SYMBOL	DESCRIPTION	DATE	APPR.
REVISIONS			
OFFICE OF CARL R. BLANCHARD JR. ARCHITECTS	DEPT. OF THE NAVY BUREAU OF YARDS & DOCKS		
NEW HAVEN, CONNECTICUT	DISTRICT PUBLIC WORKS OFFICE		
	THIRD NAVAL DISTRICT		
	U.S. NAVAL SUBMARINE BASE - NEW LONDON - GROTON, CONNECTICUT		
CHapel & Religious Education Building			
PLOT PLAN, LOCATION MAP & TEST BORING DATA			
DESIGNED BY [Signature]	DATE [Date]	CODE IDENT NO	SIZE
DRAWN BY [Signature]	DATE [Date]	1082655	33" x 42"
APPROVED [Signature]	DATE [Date]	NBY 63823	
OFFICER IN CHARGE	DATE [Date]	SCALE AS NOTED	SPEC 63823/65
APPR. FOR BLDG. OFFICE	DATE [Date]		
APPR. FOR CHIEF OF BUREAU	DATE [Date]

SYMBOL	DESCRIPTION	DATE	APPR
△	DRIVE, PARKING AREA & GRADING MODIFIED; WALKWAY FEEL LANE ELIMINATED.	6/9/68	
△	REV LAYOUT OF DRIVE & DRAINAGE	4/5/68	
REVISIONS			
OFFICE OF CARL R. BLANCHARD JR. ARCHITECTS NEW HAVEN, CONNECTICUT		DEPT. OF THE NAVY THIRD NAVAL DISTRICT NEW YORK, N.Y.	
DES. WD. DR. RG. CHK. WD. SUPV. CC. CH. ENGR. CC.		BUREAU OF YARDS & DOCKS DISTRICT PUBLIC WORKS OFFICE NEW YORK, N.Y.	
U.S. NAVAL SUBMARINE BASE - NEW LONDON - GROTON, CONNECTICUT			
CHAPEL & RELIGIOUS EDUCATION BUILDING			
PLOT PLAN			
APPROVED	DATE	CODE IDENT NO.	SIZE

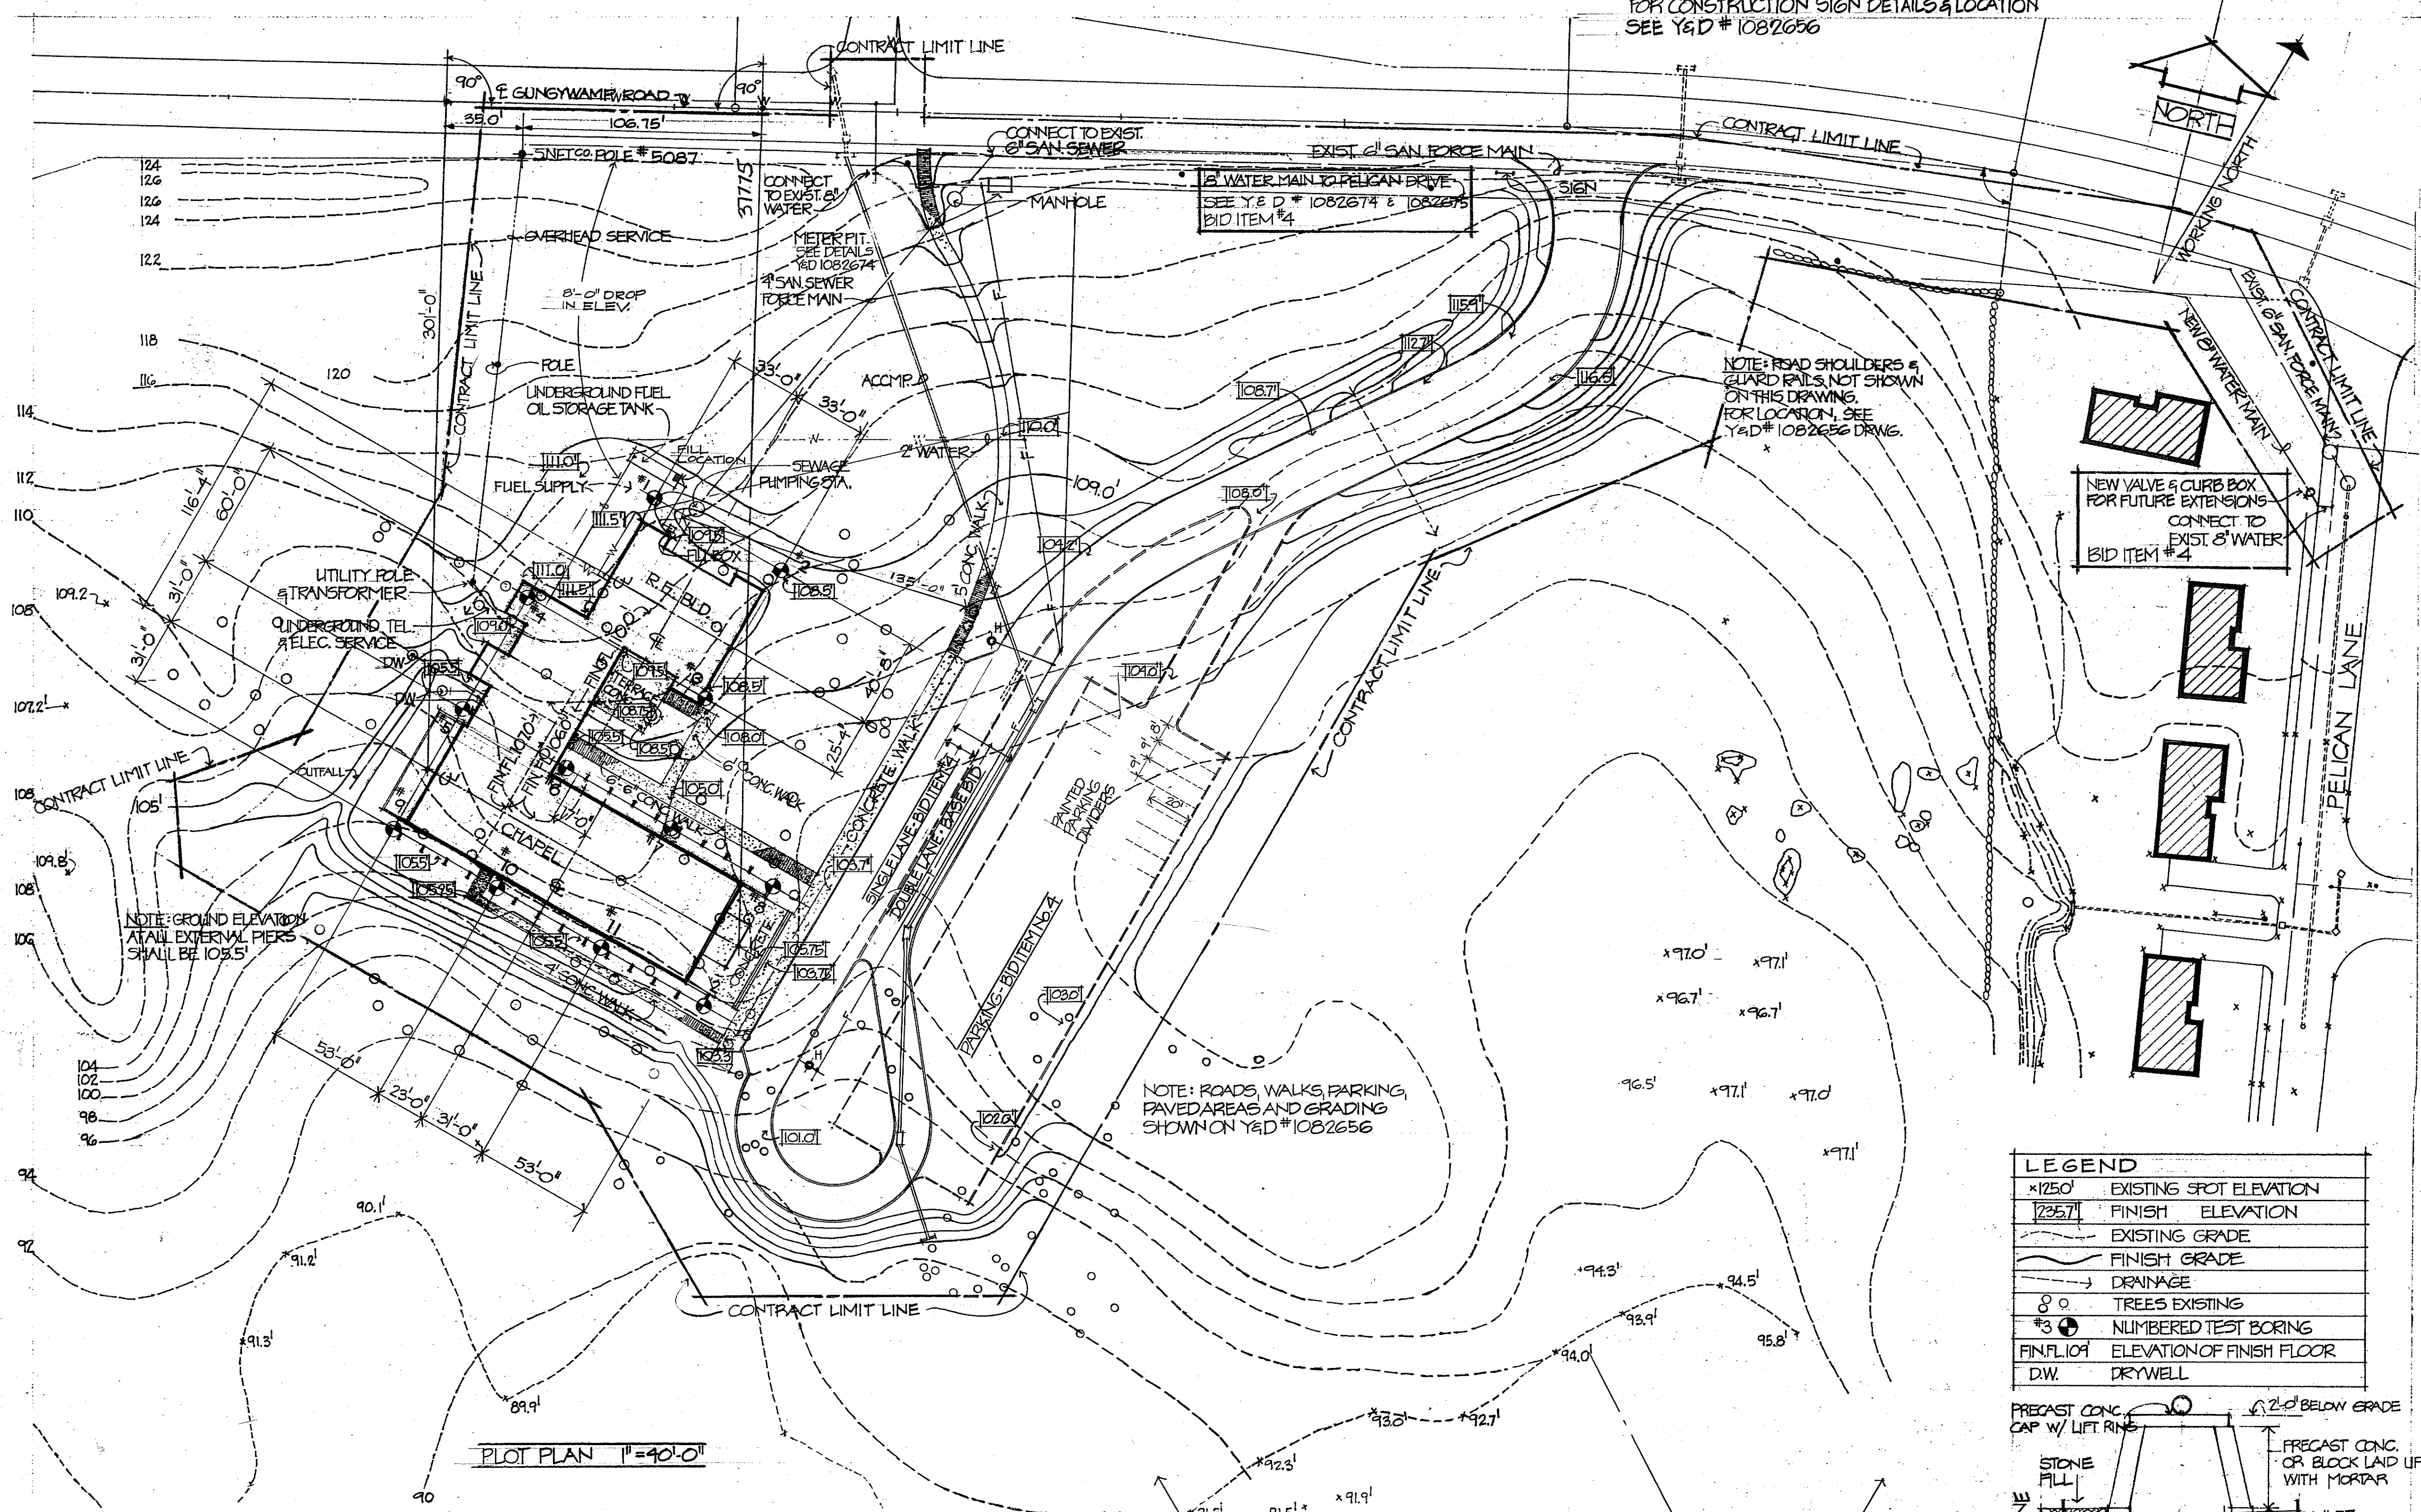
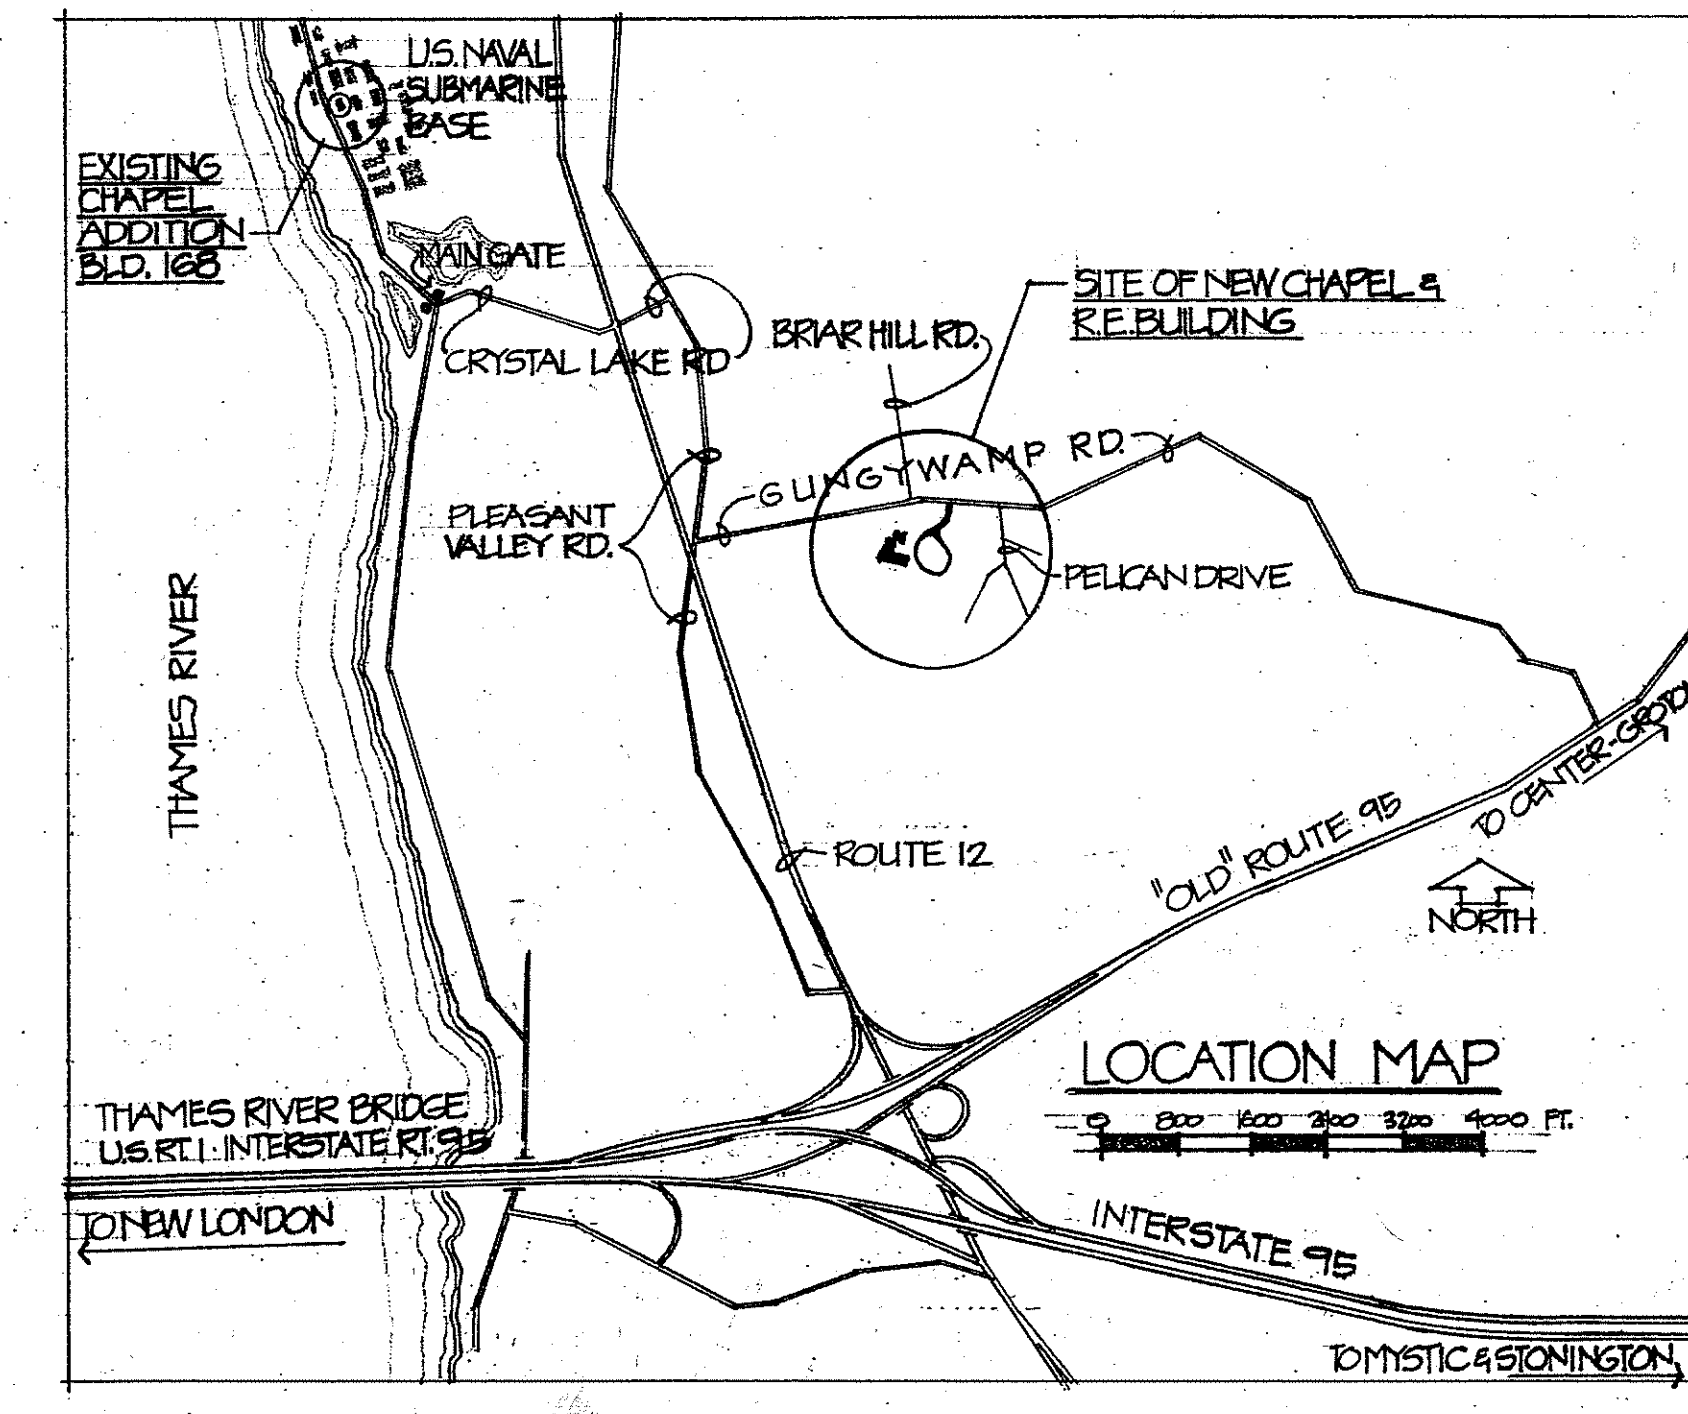
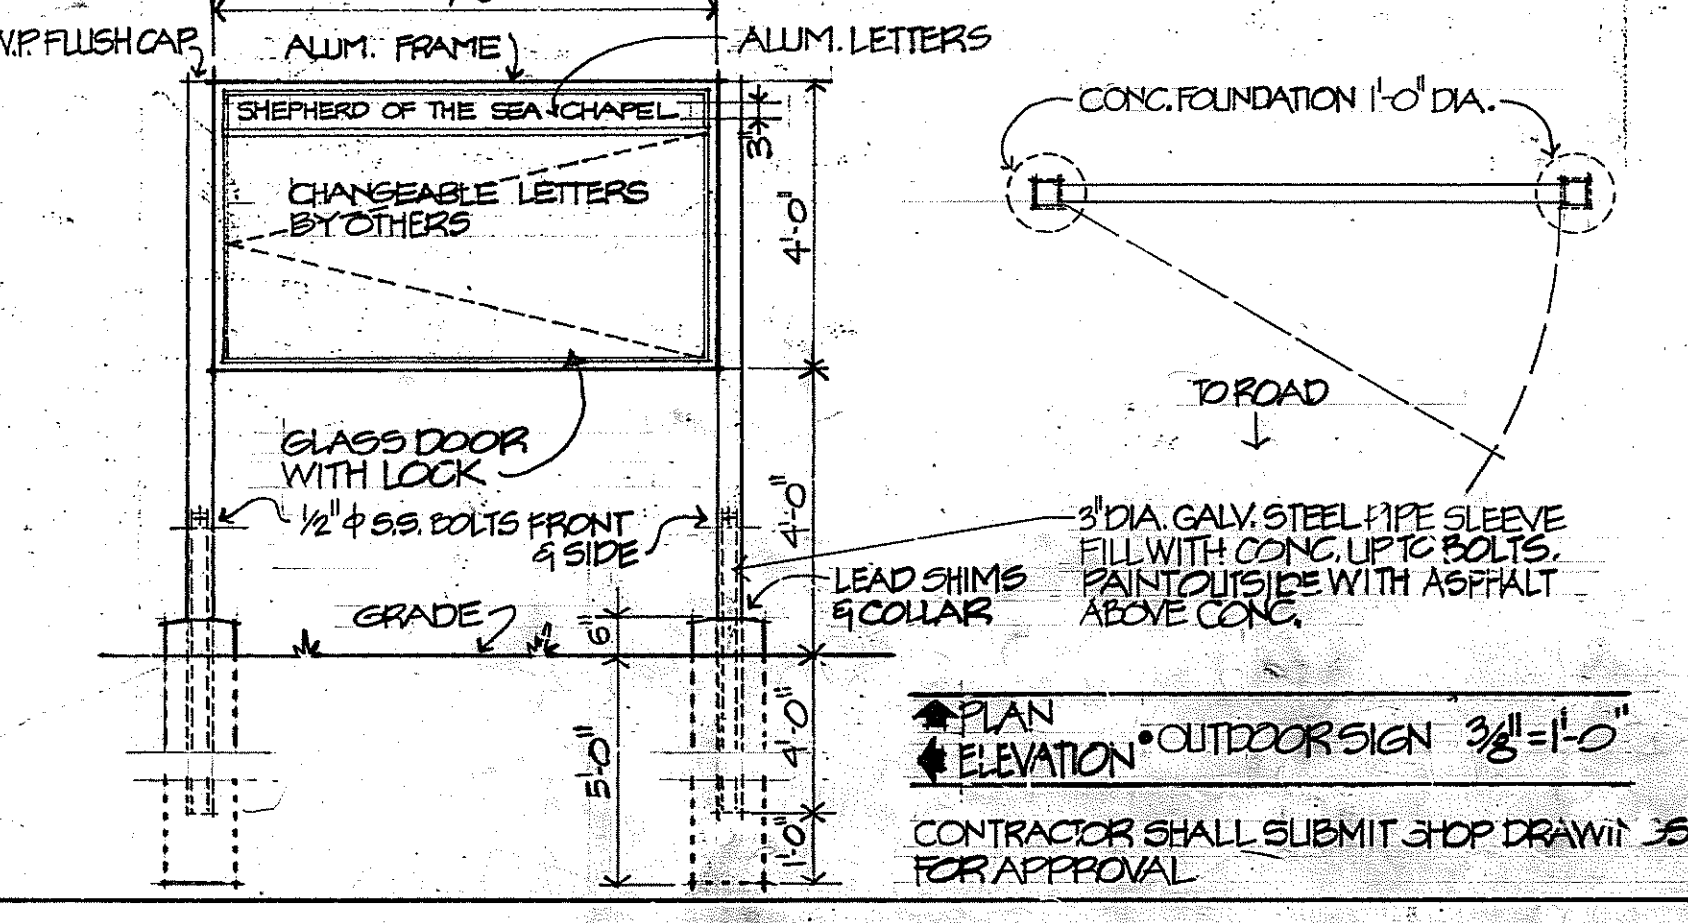
ENTRY ROAD & PARKING ALTERATIONS, CONTOURS ALTERED FOR DRAINAGE, CHANGES TO OUTDOOR SIGN, ADDITION OF VALVE & CURB BOX - 8" WATER MAIN.
